February 22, 2002

SUBJECT: SUMMARY OF JANUARY 31, 2002, PUBLIC MEETING WITH THE
NUCLEAR ENERGY INSTITUTE REGARDING THE GENERIC
IMPLICATIONS OF THE THREE MILE ISLAND UNIT 1 (TMI-1) TUBE
SEVER EVENT

Generic Implications of TMI Tube
Sever Event

Tubes With Damage Surrounding B66-130

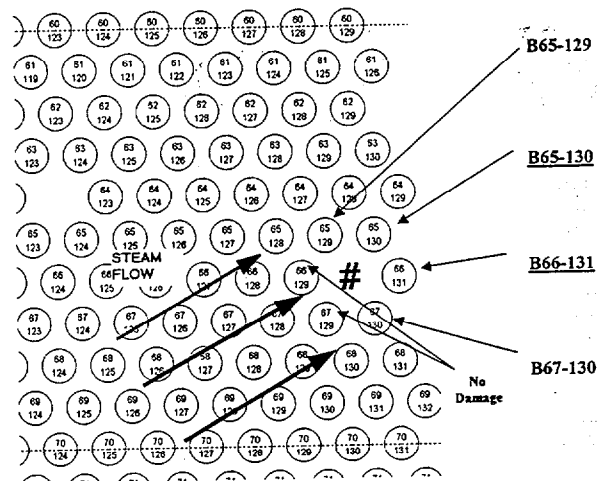
■ Two severed tubes

- B66-130, Severed at UTSF
 - ◆ Impacted 4 surrounding tubes
 - ◆ Original UTS Alloy 600 rolled plug replaced in 1997 with Alloy 690 (ribbed A-600 at bottom)
- A2-24, Severed at 15th TSP
 - ◆ No impact on surrounding tubes
 - ◆ Westinghouse Alloy 600 rolled plugs top and bottom, re-rolled after hot functional testing

■ One axial burst

- B150-14, Opening in Top Span
 - ◆ Original UTS Alloy 600 rolled plug replaced in 1997 with Alloy 690 (ribbed A-600 at bottom)
